ORIGINATION FORM

Proposed Revisions to a Standard Plans Index
(Please provide all information — Incomplete forms will be returned)

Index Number: 520-010
Sheet Number (s): All
Index Title: Median Opening Flume

Redrew details; Rewrote notes

NEW SUB SECTION: MEDIAN OPENING DETAILS

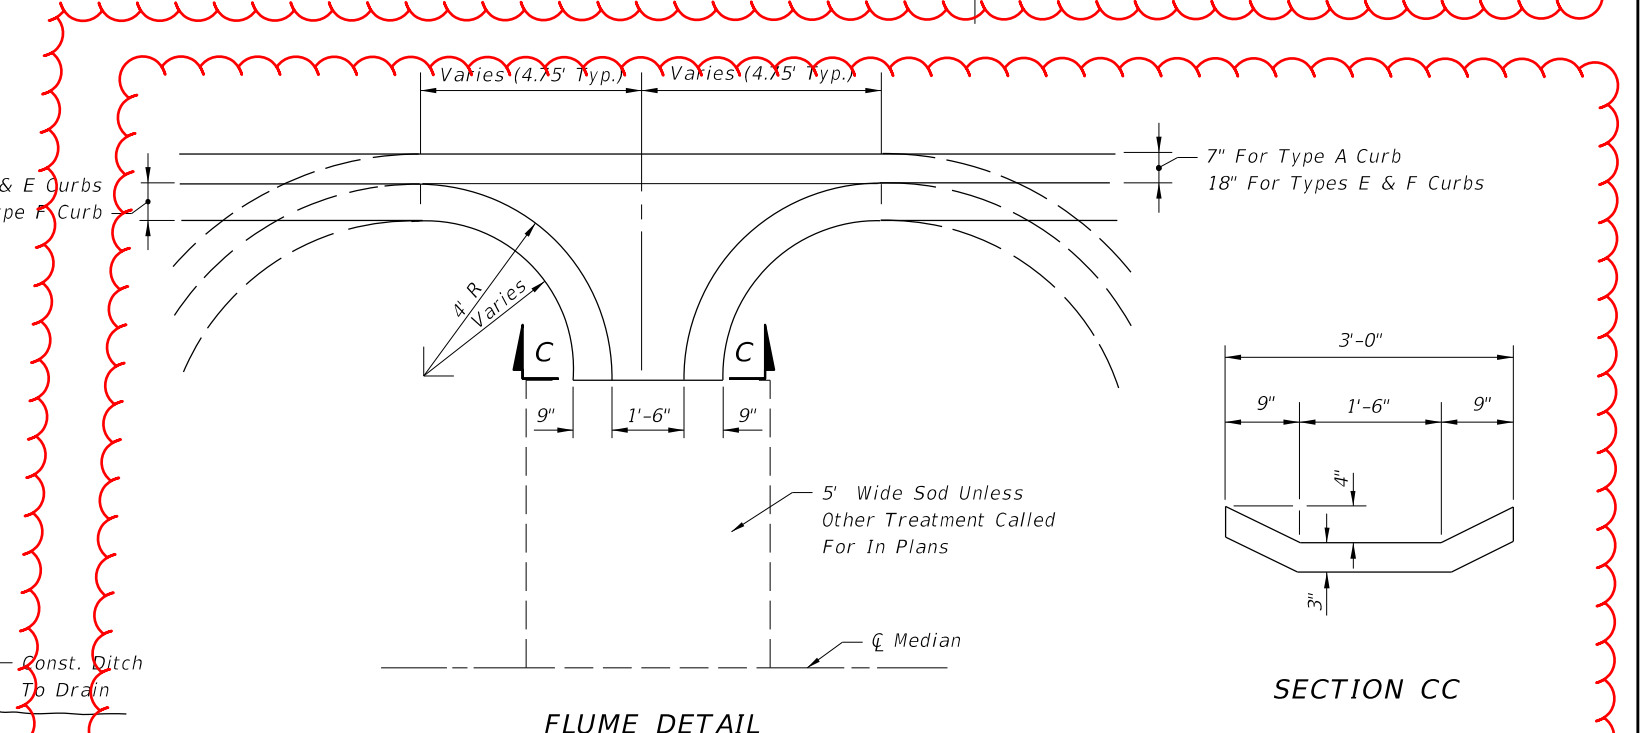
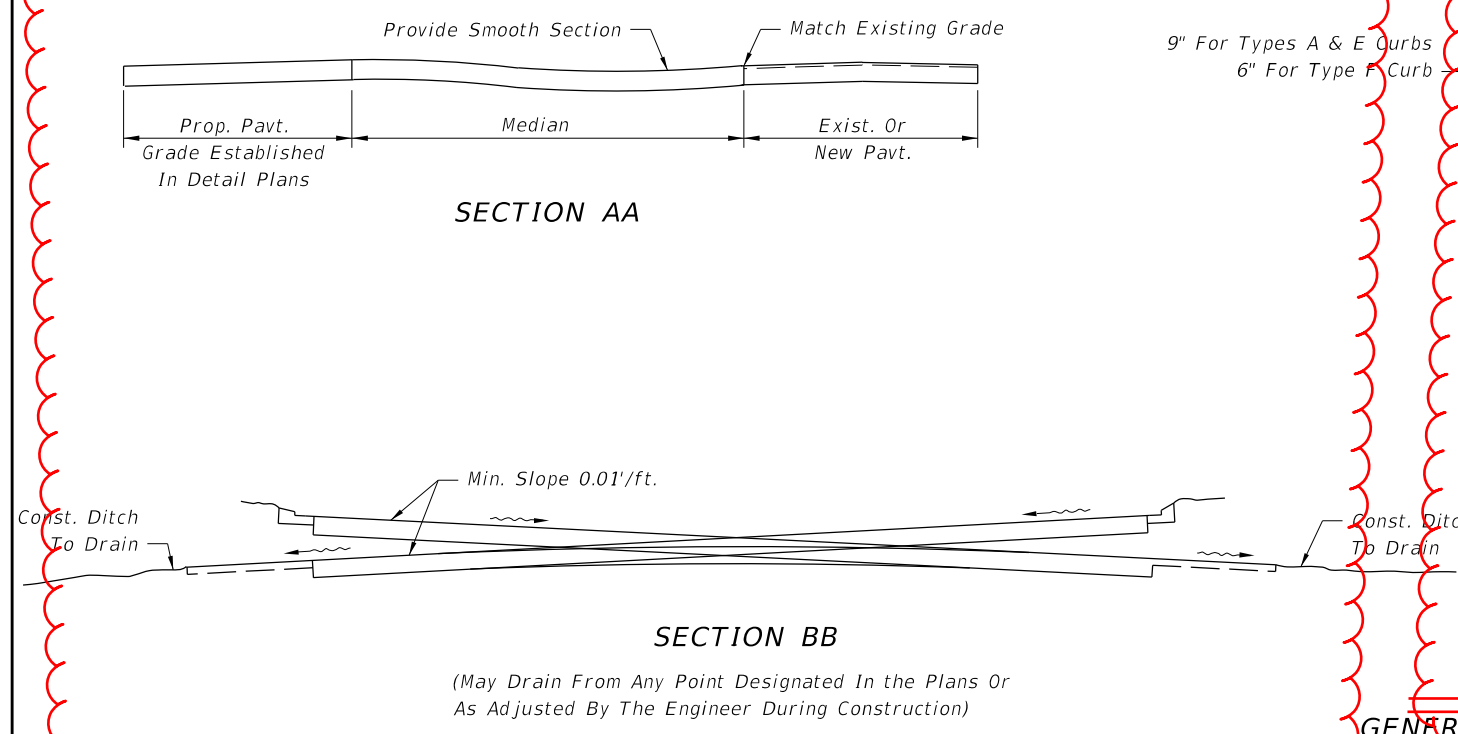
REDEVELOPED INDEX

Created new Note 2

~~Provide Approximately A Minimum Of 0.20% Grade On Gutter, Slightly Warping The Surface Of The Median Pavement If Necessary, Within Limits Of The Median Curb Or Curb And Gutter. Construct A Drainage Flume Or Flumes At The Point Or Points Of Low Grade. See Details.~~

LAST REVISION 11/01/21	REVISION	DESCRIPTION:		FY 2022-23 STANDARD PLANS	MEDIAN OPENING FLUME	INDEX 520-010	SHEET 1 of 1
---------------------------	----------	--------------	--	------------------------------	----------------------	------------------	-----------------

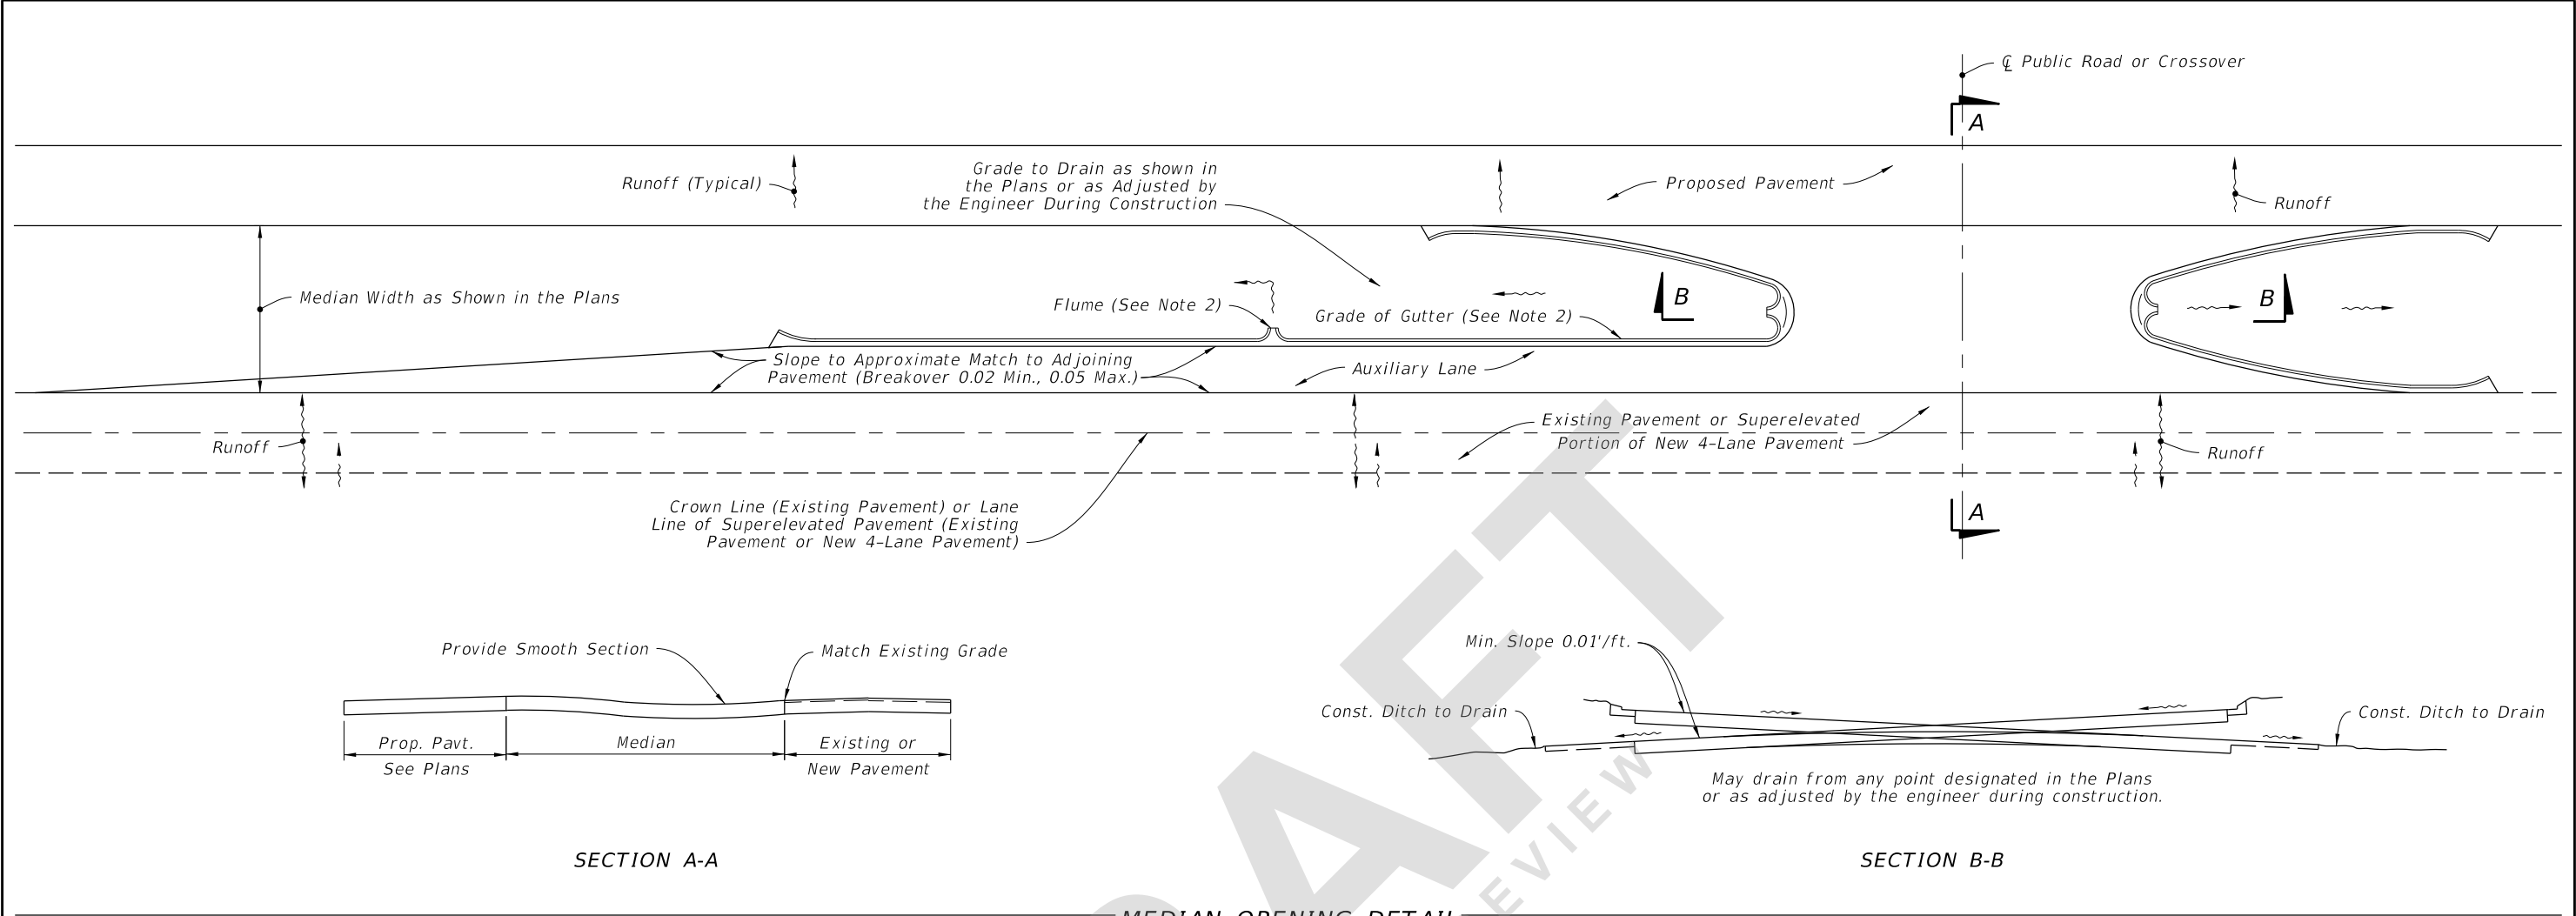
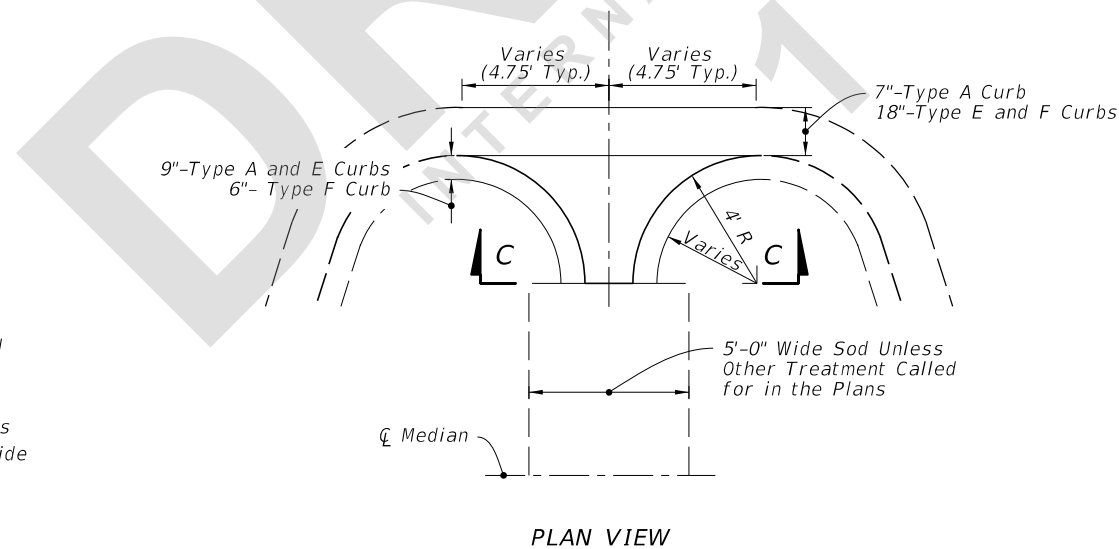
Revised and reorganized details to match other indexes. Rewrote notes and deleted pay item and design information that is now located in the SPI.

Update notes to remove payment info and delete design criteria that is located in SPI

1. These details are to apply to projects which provide for the conversion of 2-lane sections to 4-lane divided highway sections and for superelevated sections of new 4-lane divided highways. Layout above is illustration only.
2. See Plans for flume length and location and grade of gutter. Flume locations may be adjusted by the Engineer during construction. If necessary to provide minimum gutter grade, warp surface of the median pavement within limits of the median curb or curb and gutter.
